SUNDRY NOTICES AND REPORTS ON WELLS

PLUG AND ABANDONMENT PROCEDURE

Jicarilla 98 #1

CONDITIONS OF APPROVAL

Proposed P&A

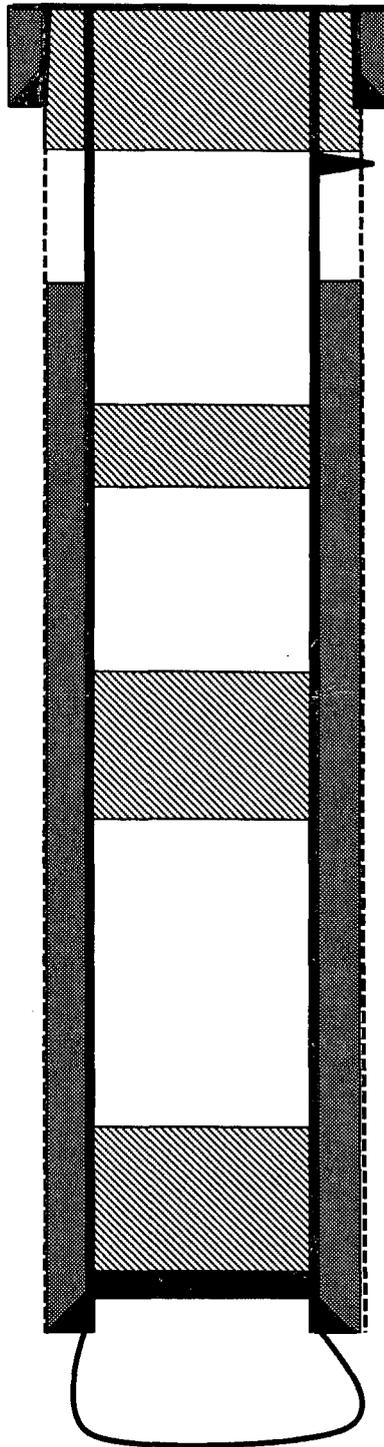
1. Plugging operations authorized are subject to the attached "General Requirements for Permanent Abandonment of Wells on Federal and Indian Leases."
2. Farmington Office is to be notified at least 24 hours before the plugging operations commence (505) 564-7750.
3. The following modifications to your plugging program are to be made:
 - a) Bring the top of plug #1 to 3609 ft. to cover the Pictured Cliffs and Fruitland formation tops. Adjust cement volume accordingly. Note: Plugs 1 & 2 can be combined (3890-3343) ft.

Operator must run a CBL from 3890 ft., or as deep as possible, to verify cement top. Outside plugs will be required, based on CBL result. Submit electronic copy of the log for verification to the following BLM address: tsalyers@blm.gov

You are also required to place cement excesses per 4.2 and 4.4 of the attached General Requirements.
